**TRUCK UTILITY LIGHT (TUL)HS, TRUCK UTILITY
MEDIUM (TUM)HS AND (TUM) AMBULANCE HS**

GENERAL INSTRUCTIONS INDEX

Ministry of Defence
Issued by
ARMY TECHNICAL SUPPORT AGENCY
DIRECTORATE OF TECHNICAL SERVICES

Fig 1. Fitting the stop clip

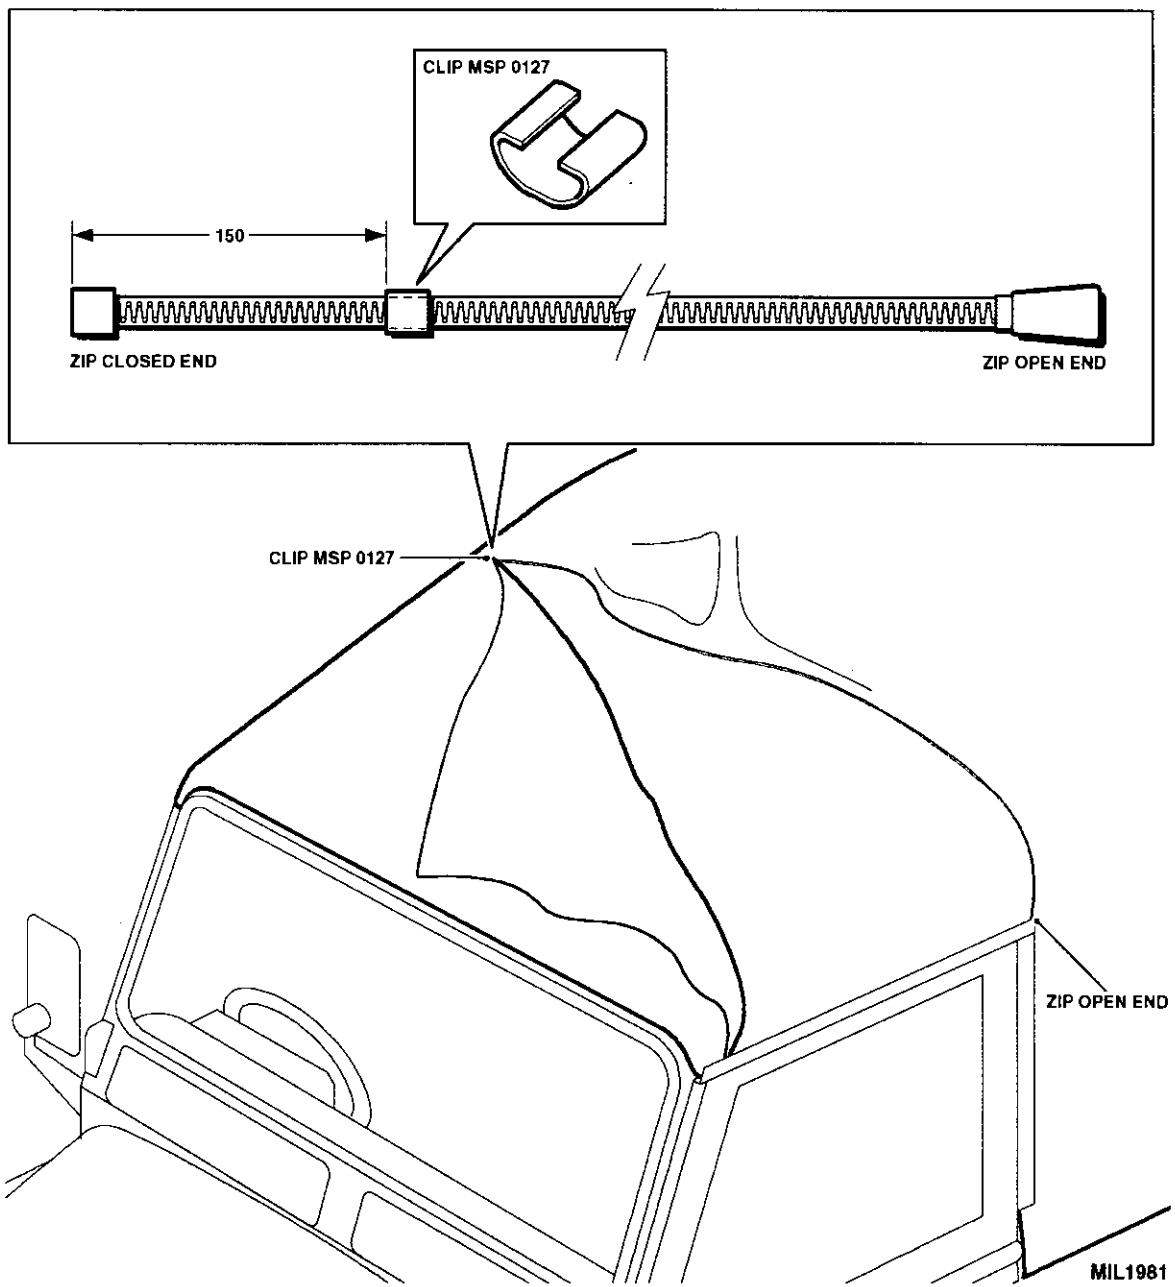
1 This instruction details the fitting of a stop clip to the escape hatch zip of Soft Top Winter/water vehicles to improve the open and closing operation of the zip.

- 6 Carry out the modification as follows:
 - 6.1 Park vehicle on a level surface and apply hand brake.
 - 6.2 Switch off engine and remove ignition key.
 - 6.3 With canopy fitted to vehicle, open escape hatch zip until approximately 150mm from the zip closed end (refer to Fig 1).
 - 6.4 Place stop clip (Serial No 1) over closed part of zip (150mm from closed end) and using a suitable pair of pliers between the open parts of the zip, crimp stop clip in position over zip.
 - 6.5 Move zip against stop clip to ensure the clip remains in position.
 - 6.6 If stop clip moves, apply further crimping pressure with the pliers.
 - 6.7 Close escape hatch zip and secure canopy.

Fig 1. Fitting the tailgate cable assembly

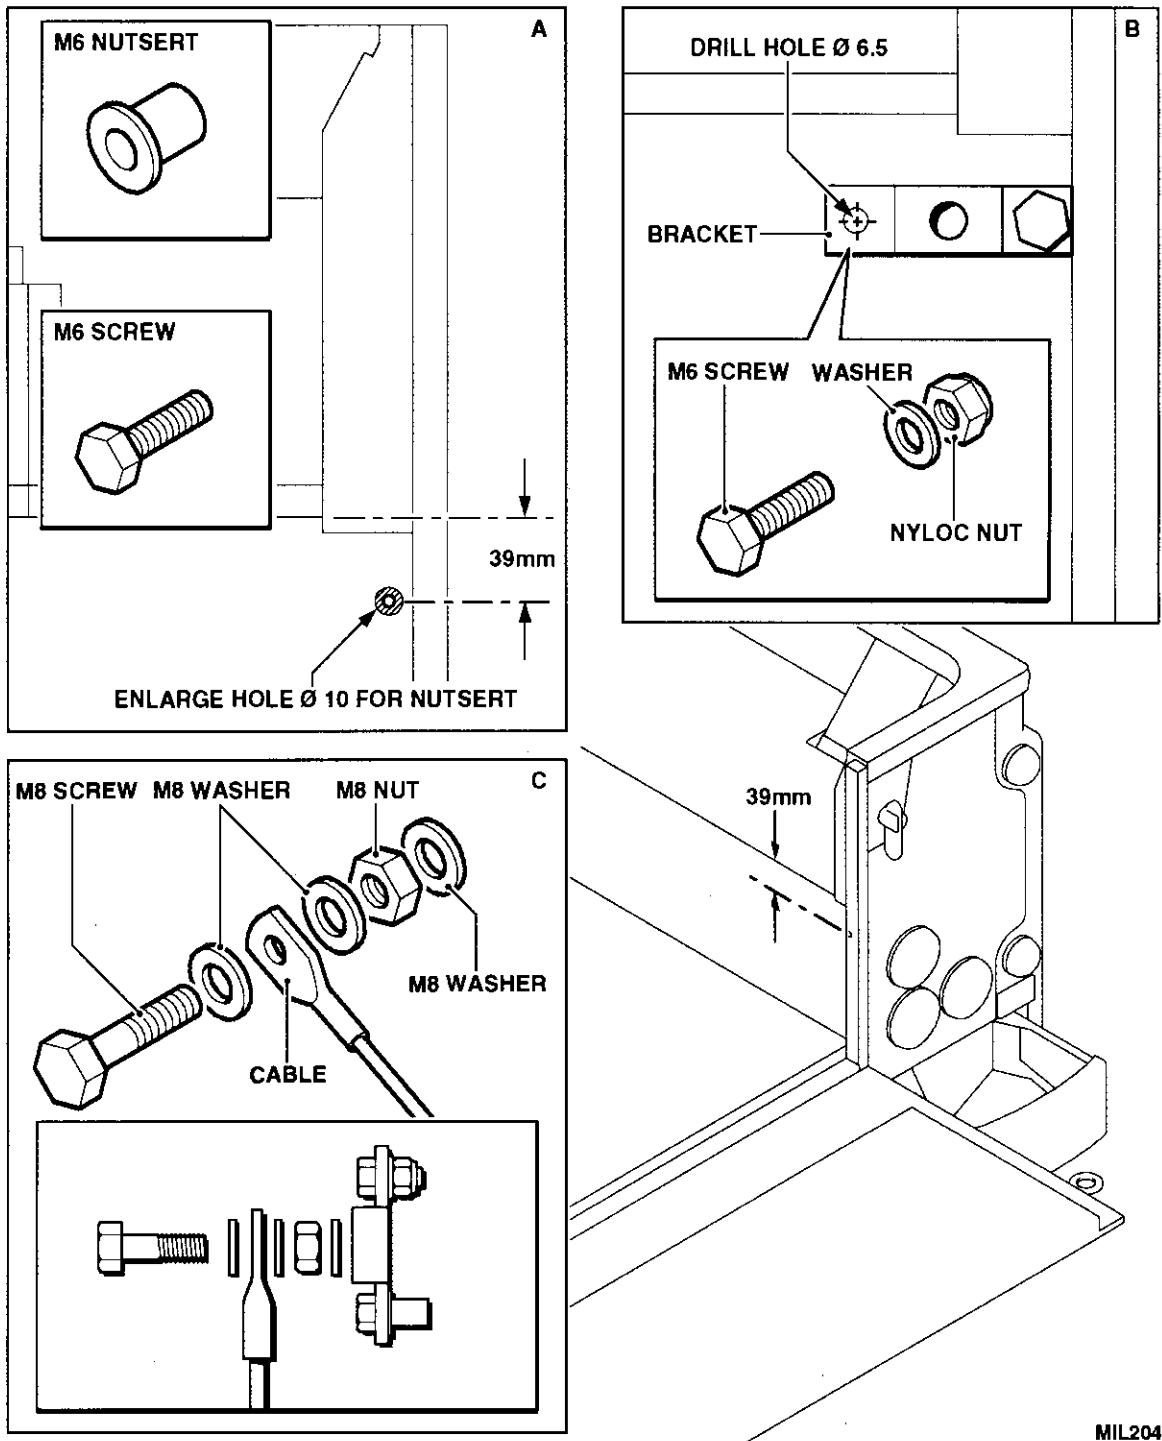
1 This instruction details the fitting of a modified tailgate cable assembly to prevent the cable from jamming on the tailgate seal when the tailgate is open and under a heavy load.

- 6.3 Open tailgate and support to prevent damage with cables removed.
 - 6.4 Remove existing cables.
 - 6.5 Drill out the upper rivet on each wheel arch box (39 mm below top face of wheel arch box) and enlarge holes to 10 mm diameter. (refer to Fig 1)

- 6.6 Fit M6 nutserts (item 4) into 10 mm holes and secure.
 - 6.7 Fit brackets (item 2) horizontally using screws (item 3) and secure rear of brackets to nutserts (refer to Fig 1).

- 6.8 Using bracket as a guide, drill forward hole (6.5 mm dia) into wheel arch.
 - 6.9 Using screws (item 3), plain washers (item 5) and nyloc nuts (item 6) secure the forward end of the brackets to wheel arch boxes.

- 6.10 Torque fixings to 6Nm.
 - 6.11 Assemble cables to brackets (refer to Fig 1) using nuts (item 8) and washers (item 9) to adjust clearance so that cable ends are free to rotate on screws (item 7).
